Ref: NL203697-00-FL-LE01-1

**Re: DA24/0075 Civitas Stage 3 – Response to RFI**

We have received and reviewed the RFI request from Wagga Wagga City Council dated 21 February 2025 and associated email to Manuel Donebus from Steven Cook. This has been reproduced along with our responses below in Table 1 Table 2 and Table 2.

*Figure 1: Extract from Guide to Road Design Part 5: Drainage - General and Hydrology Considerations*

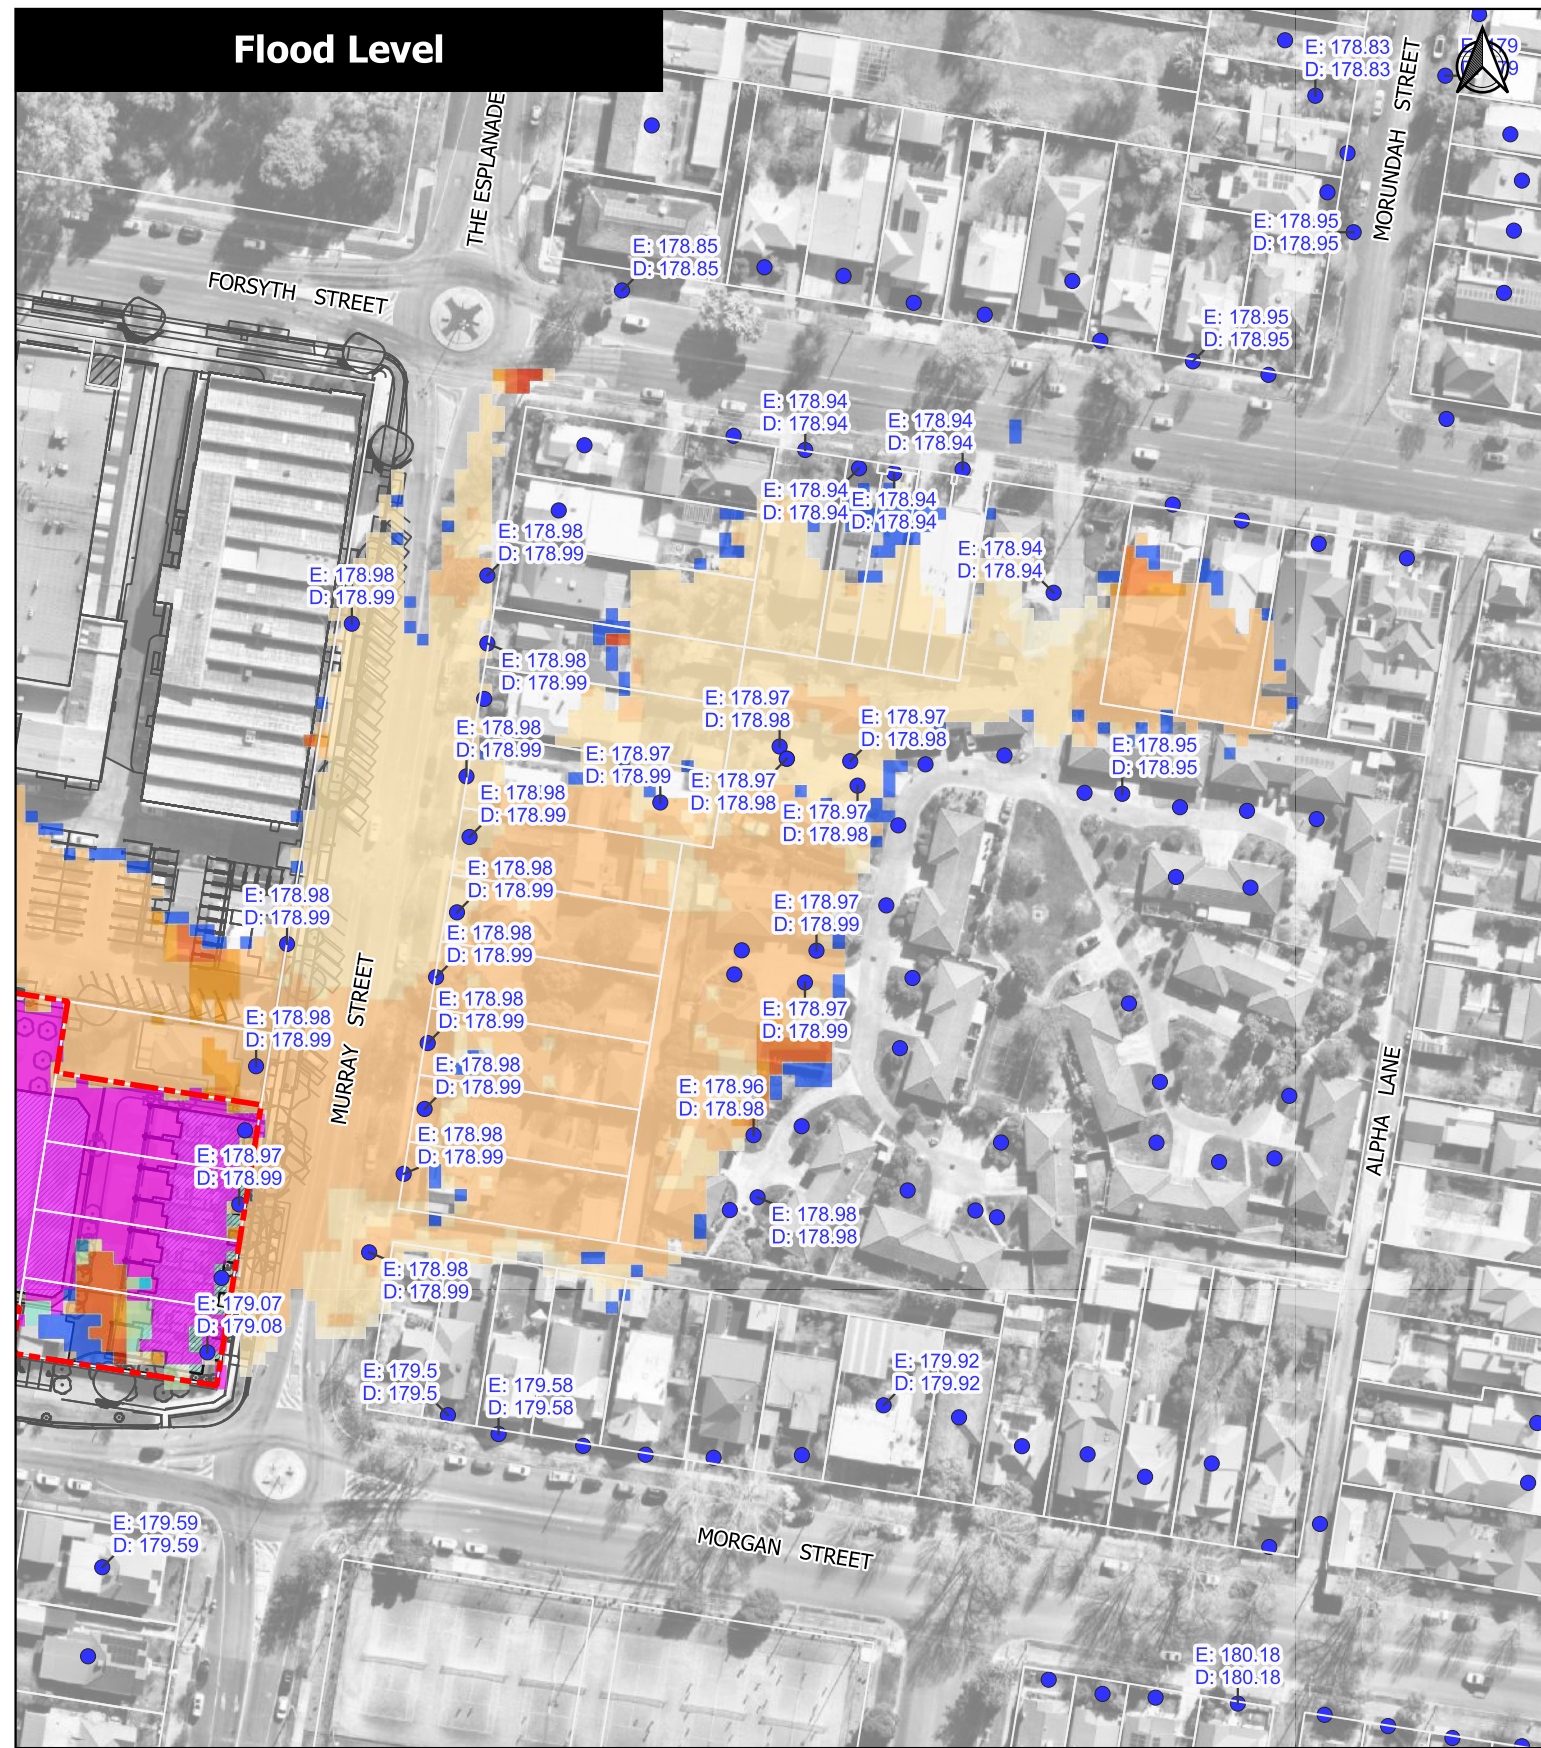
3. In the event that the results of the survey shows that the development results in new, or increased above floor inundation of any one of these properties, measures to reduce flooding impacts to no greater than 10mm.	We have always understood that whilst 10mm impact was the target, Council was willing to accept increases less than 20mm which has been demonstrated.

*Figure 2: Extract from Wagga Wagga City Local Flood Emergency Sub-Plan (2021)*

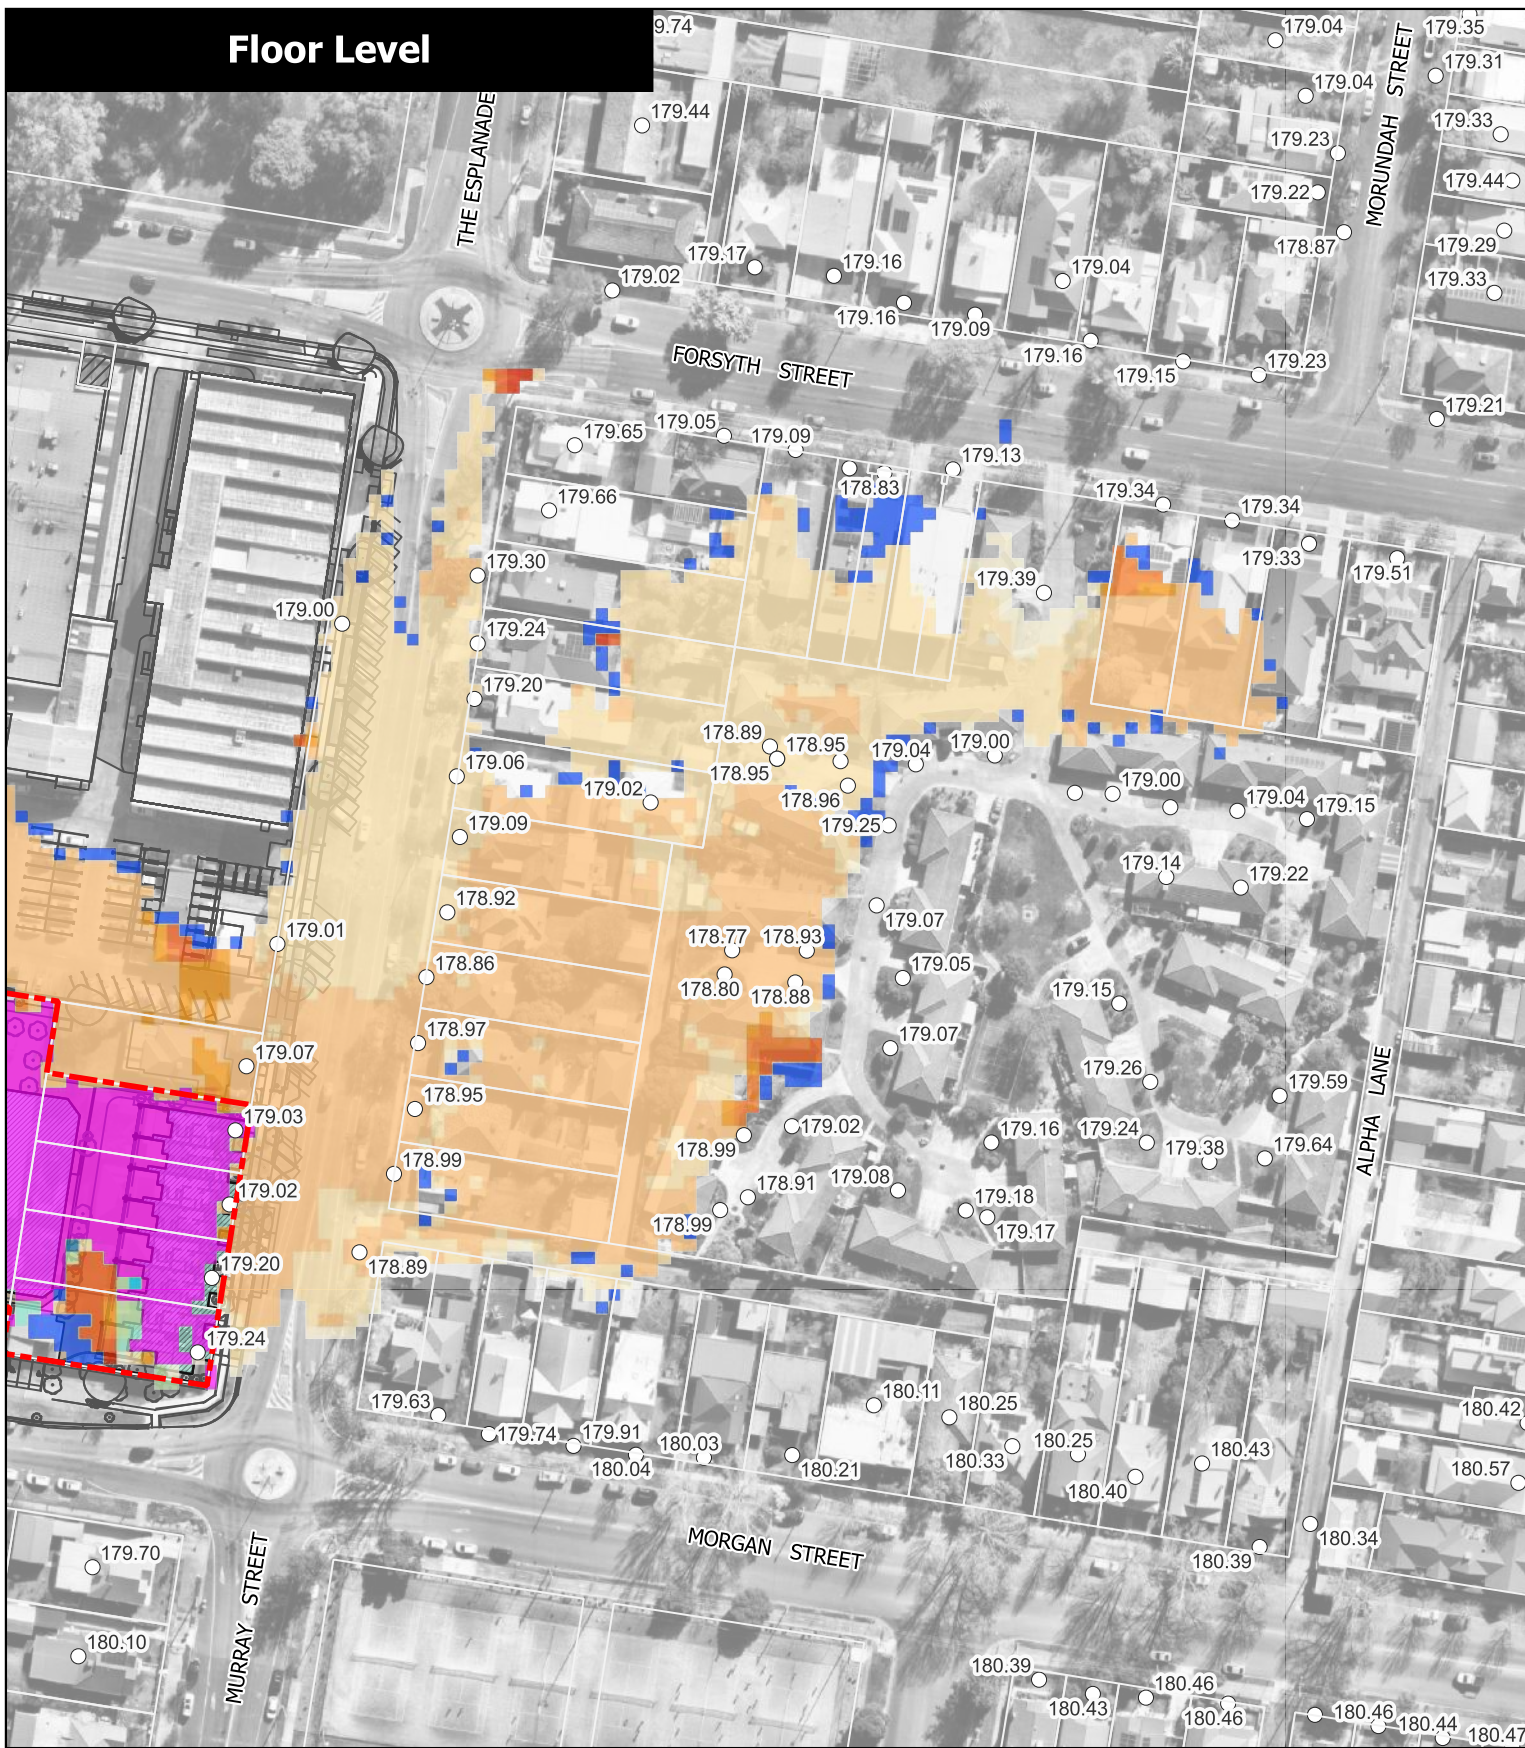
<p>iii. The Rev B report shows the impact of the proposed development during a 5% AEP storm event will be much broader than was documented in Rev A of the report (refer attached pdf).</p>	<p>This is noted and the modelling changed between these revisions which resulted in a change in results.</p>
<p>iv. The report advocates a shelter-in-place approach to managing the residual flood risk in the proposed development but does not specifically address its nature or how it will be managed, both in terms of local catchment <u>and</u> riverine flooding. The only reference to the PMF from a shelter-in-place perspective is set out on pg 21 in response to sub-clause 5.22(a) of the LEP, which states:</p>	<p>An extract from the Wagga Wagga City Local Flood Emergency Sub-Plan (2021) is presented in Figure 2 of the attachments.</p> <p>This notes significant warning time of approximately 20 hours in a riverine flooding mechanism. We believe this is sufficient warning time for an evacuation.</p>

**Figure E1**  
 Pre-to-Post Comparison  
 10% AEP Flood Levels  
 Relative to Existing Floor Levels

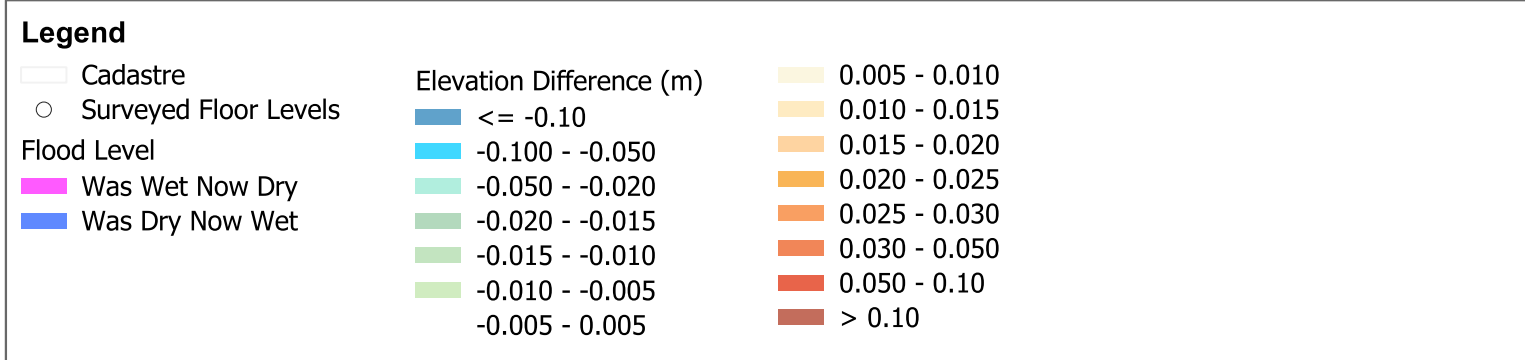
2. Details of a survey of all properties impacted by increased flooding establishing the floor levels of these properties. These floor levels shall then be used to ascertain whether the increase in flooding results in new above floor level inundation or increased above floor inundation.	Floor level data was provided by Council on the 21 <sup>st</sup> October 2022 and has been used to assess the impact of flood levels relative to the existing floor level.  Figure E 1, Figure E 2, and Figure E 3 showing this assessment are presented in the Attachments.  There are no new instances of "over-floor" flooding based on this data.
